BUILDINGS ORDINANCE (Chapter 123)
(Section 35)

BUILDINGS ORDINANCE (CAP. 123)
Order by the Building Authority under section 24(1)

Order No.:	C/TB/006085/20/HK	Office of the Building Authority
BD Ref. :	EB/2196/54/N01S/17-19	Buildings Department Headquarters,
To :	THE OWNER OF	North Tower, West Kowloon Government
	NOS. 17-19 LAN FONG ROAD HONG KONG	Offices, 11 Hoi Ting Road, Yau Ma Tei,
		Kowloon.

Owner(s) of the premises at: NOS. 17-19 LAN FONG ROAD HONG KONG
on (Lot Number) SUB-SECTION 9 OF SECTION R OF INLAND LOT NO. 29 AND
SUB-SECTION 10 OF SECTION R OF INLAND LOT NO. 29

G/F Plan
 地下平面圖

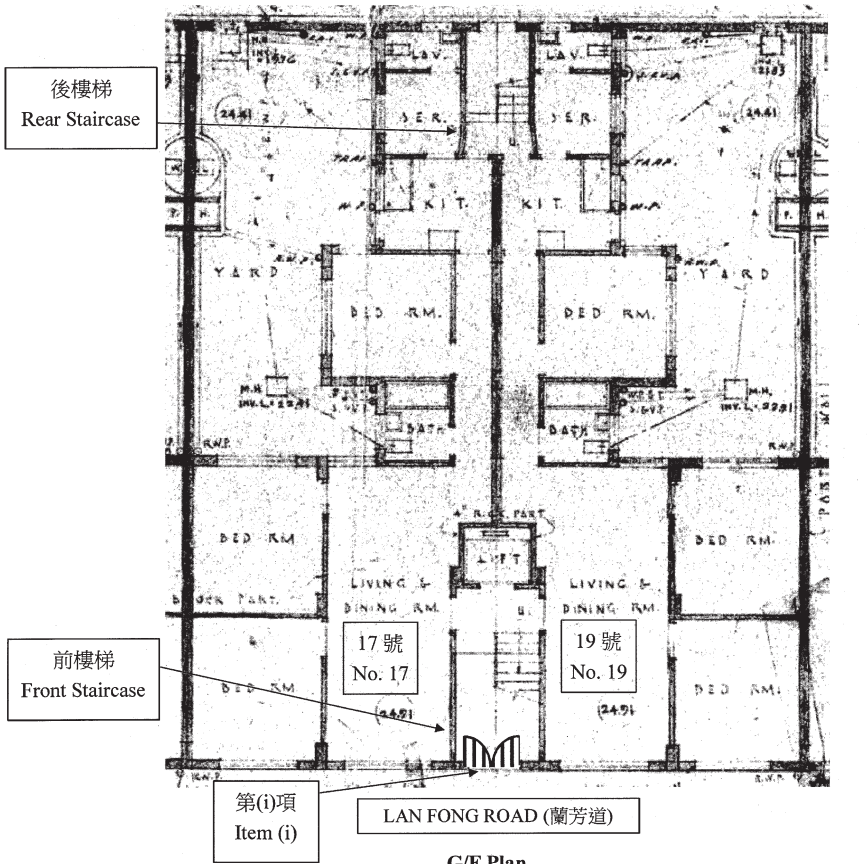
- (i) An inward swinging metal gate installed at the exit of the front staircase on G/F leading to Lan Fong Road.

2. For the said building works:
- (a) As a result of the building works at item (i) above, Regulation 41(1) of the Building (Planning) Regulations, which requires the building to be provided with such means of escape in case of emergency as required by the intended use of the building, has been contravened.

3. In exercise of the powers vested in me under section 24(1) of the Buildings Ordinance, I hereby order you to :-
- (a) Demolish the said building works described under item (i) above; and

- (b) Reinstatement of the parts of the building so affected by the building works under item (i) above in accordance with the plans approved by the Building Authority.
